EXHIBIT 1
DEPARTMENT OF PUBLIC WORKS AND DEVELOPMENT SERVICES
STAFF REPORT
TO THE CITY OF MILL CREEK HEARING EXAMINER

NAME OF PROJECT: Preliminary Plat of Crestview Village Phase II
File No. PL2019-0011

Preliminary Plat

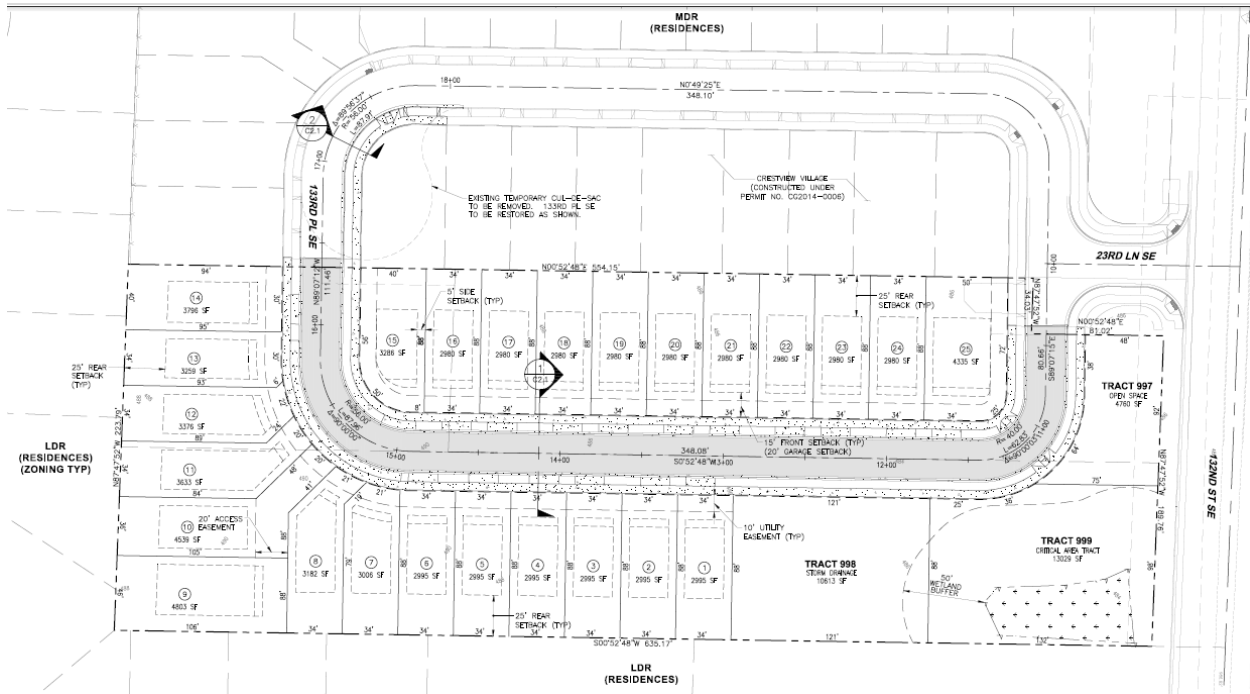
1. Development shall occur as portrayed on the Preliminary Plat Map, except as may be modified by the Hearing Examiner following the open record hearing, per MCMC Chapter 4.34.
